# F/CMVSS Noncompliance Recall

## 18159 Fuel Leak During F/CMVSS Testing

**Reference Number:** N182159480

**Revision Description:** This bulletin is being revised to change the Service Procedure section fuel tank inspection identifier to a Julian date. Please discard all previous copies of bulletin 18159.

5118291

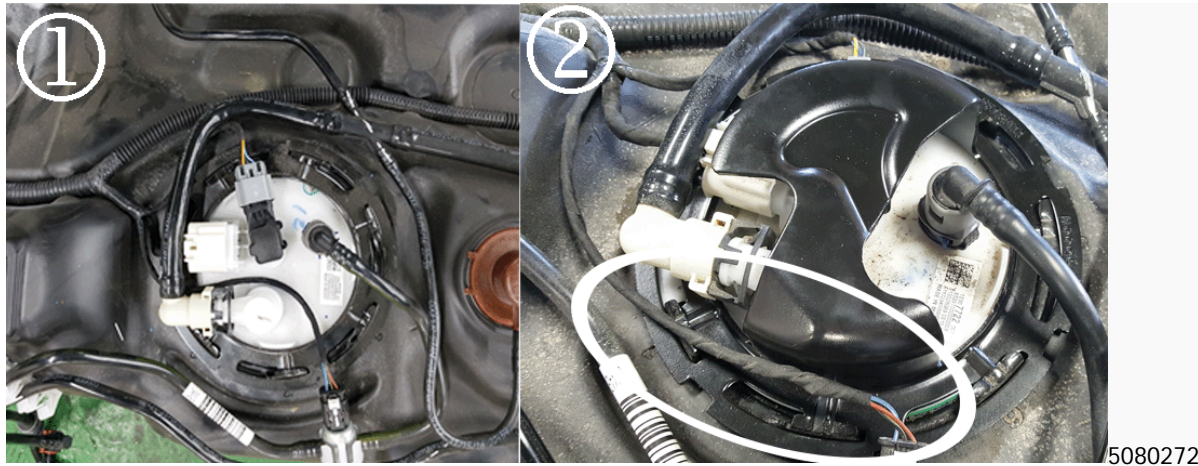
- Inspect the fuel tank label (facing the rear of the vehicle) and verify the julian date of production.
  - (1) Must be 18 or higher
  - (2) Must be 124 or higher
  - (3) Must be 1072 or higher
- If the Julian date meets these criteria, no further action is required. If the Julian date does NOT meet **any** of these criteria, proceed to step 4.
